1 Products affected

Product hierarchy no.				Part no.	SBU	Product Type	Customer part no.
SBU	PG	PUG	Type				
01	002	060	0000000660	See list below	Circuit Protection	OGN Cover	-
01	002	060	0000000683	See list below	Circuit Protection	OGD Cover	-

Product Change Notification					OGN_OGD Cover Change of production site		
owner	creation date	release date	released by	change order	rev	page	
hubacepe	13.04.2026	13.04.2026	schulejo		A	1 of 1	D10-099-525

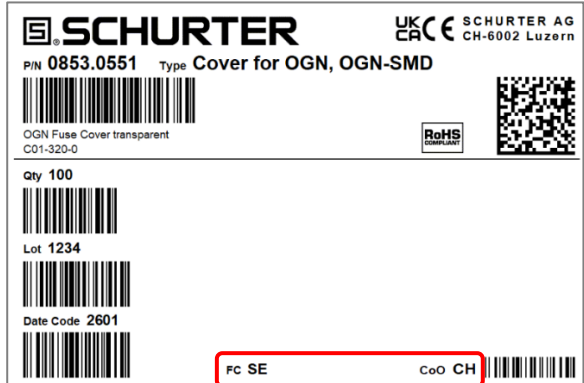
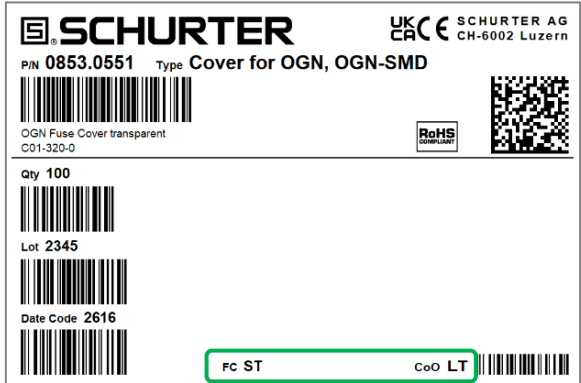
Current Packaging label production site Switzerland	New Packaging label production site Czech Republic
 The label for Switzerland shows: SCHURTER UK CE SCHURTER AG CH-6002 Luzern, PIN 0853.0551, Type Cover for OGN, OGN-SMD, OGN Fuse Cover transparent C01-320-0, Qty 100, Lot 1234, Date Code 2601, FC SE, CoO CH.	 The label for Czech Republic shows: SCHURTER UK CE SCHURTER AG CH-6002 Luzern, PIN 0853.0551, Type Cover for OGN, OGN-SMD, OGN Fuse Cover transparent C01-320-0, Qty 100, Lot 2345, Date Code 2616, FC ST, CoO LT.

- Change of factory code (FC) from SE to ST
- Change of country of origin (CoO) from CH to LT
